Record of Executive Business and Chief Executive's Order

Reg. Reference: SD22A/0295 **Application Date:** 30-Jun-2022
Submission Type: Additional **Registration Date:** 30-Aug-2022
Information

Proposed Development: Two storey four bedroom detached house to side of
29 Ballyroan Heights Rathfarnham Dublin 16

Location: 29 Ballyroan Heights, Rathfarnham, Dublin 16

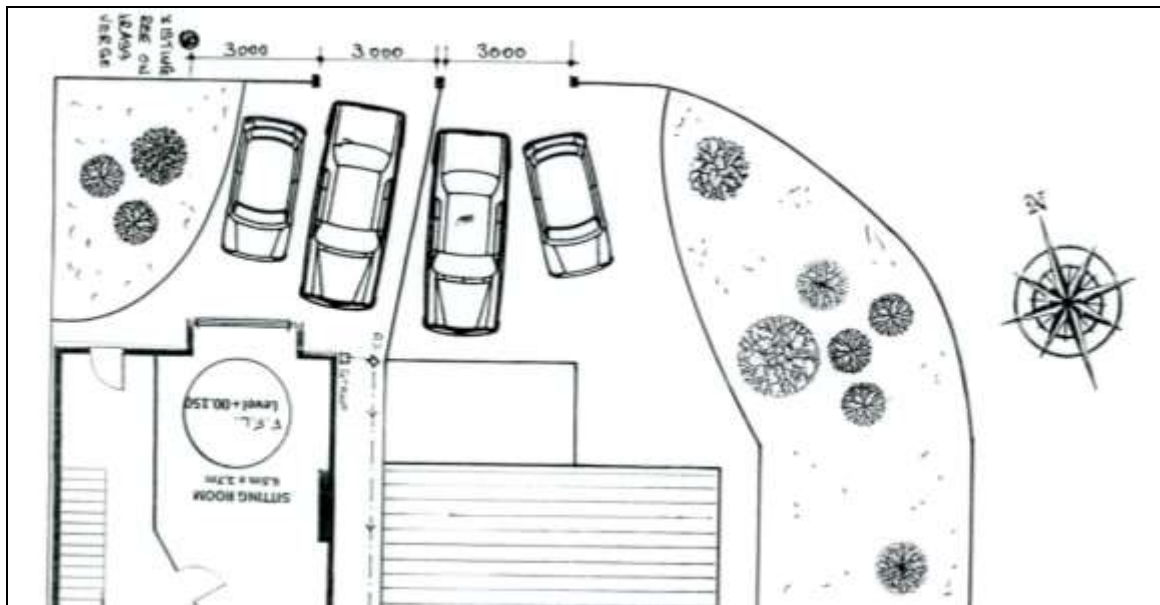
The 1/500 site layout is not consistent with the proposed floor plans – the first-floor rear element shows an inset to the west, but this is not reflected in the plan drawings.

Furthermore, the proposed ground and first floor plans are disjointed and should be shown one on top of the other and also indicate the site boundaries and the footprints of the adjacent dwellings to west and east. The applicant is requested to submit revised drawings accordingly.

In response to Item 3, the applicant submitted the following:

- Cover Letter
- Drawings 586/PD/03 indicating the width of both vehicular entrances

SDCC Roads Department is satisfied with the applicant's revised entrance layout. The applicant has not indicated the heights of the boundary walls and pillars at the vehicle access points.
